SERVICE BULLETIN

APPLICABILITY: 2022-25MY WRX

SUBJECT: Trunk Latch / Repair Procedure

NUMBER: 12-282-26

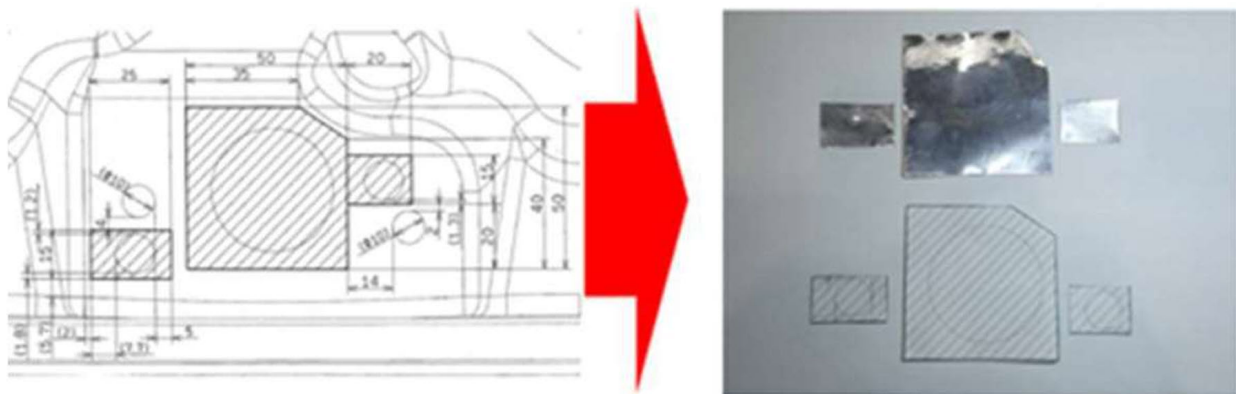
Step 1: Remove old trunk lock assembly.

Step 2: Cut tape according to the dimensions provided in the template on page 4.

Step 4: Apply the tape pieces, making sure the holes indicated below are completely covered.
